# INITIAL FIRE SAFETY INSPECTION REPORT

## FRIENDS KNITTINGS LTD (EXTENSION)

RSC ID: 25504

Date: 19 February 2024

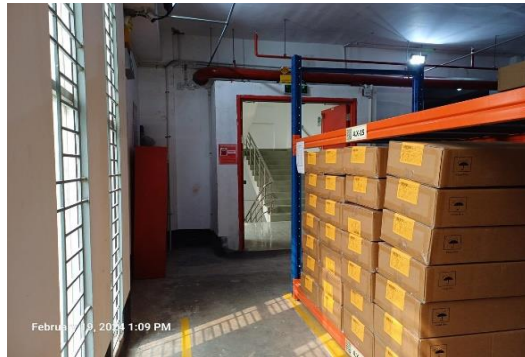
F-2	Fire Rated Construction	<p>The exit stairs are not separated from work areas and other spaces on each floor by fire rated construction.</p> <p>Gap below fire door has been found more than maximum allowable limit (19 mm), fire door has been found open with external sources and door co-ordinator for double leaf door has not been found properly functional.</p>	<p>The exit stair enclosure shall be provided with a minimum of 2- hr. fire resistance rating for buildings 4 or more stories. Provide 1.5 hr. fire rated door and seal all penetrations and openings by 2 hr. fire rated fire rated barrier construction for building with 4 or more stories.</p> <p>Provide a fire-resistive rated assembly between the exterior exit stairs and the building up to 10 ft. beyond the end of the stair to achieve the required separation. The rated assembly shall be approved and/or designed by a qualified fire protection engineer.</p> <p>Ensure that the fire doors are self-closing and positive latching and that they are provided with fire exit (panic) hardware where serving production floors. If fire doors are required to be held open for functional reasons, provide automatic closing devices tied to the fire alarm system. Once fire doors are installed, every door in a stair enclosure serving more than 5 stories shall be provided with re-entry unless it meets RSC Technical Guidelines (Standard) 6.8.3.1.</p> <p>Proper documents shall kept on site for fire door, frame &amp; accessories for verification. Clearance Between Bottom of Door and Finished Floor shall not exceed 19 mm.</p>	Within 3 months

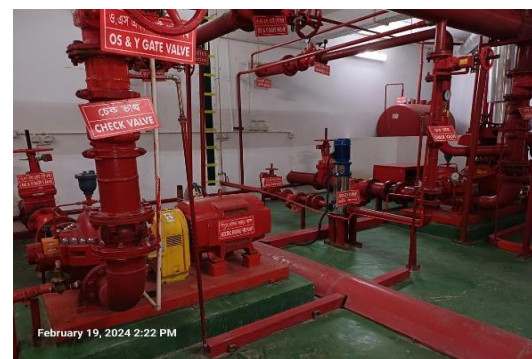
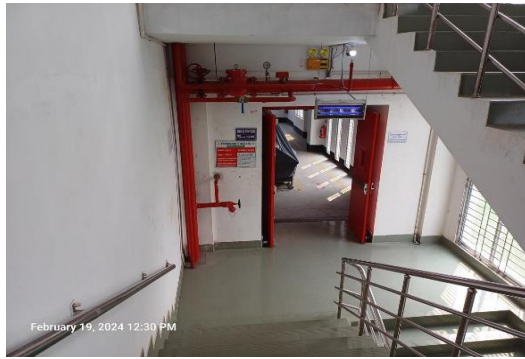
F-9	Fire Protection System (Sprinkler)	<p>The high-rise building has an occupied floor greater than 23 meter (75 feet) and is provided with automatic sprinkler protection along with standpipe system. The automatic sprinkler and standpipe system installation requires detailed review to confirm compliance with NFPA 13, 14, 20, 22, 24 and the RSC Technical Guidelines (Standard).</p>	<p>Submit as built drawings, testing records, listing information and other relevant documentation to the RSC for review and approval, modification shall have to done as per the reviewed design (if required). Class-I standpipe system is acceptable with automatic sprinkler system. The factory management shall contact RSC to conduct the final acceptance testing after the installation, testing &amp; commissioning.</p>	<p>Design- within 2 month Modification if required- within 4 months</p>
-----	------------------------------------	---	--	---
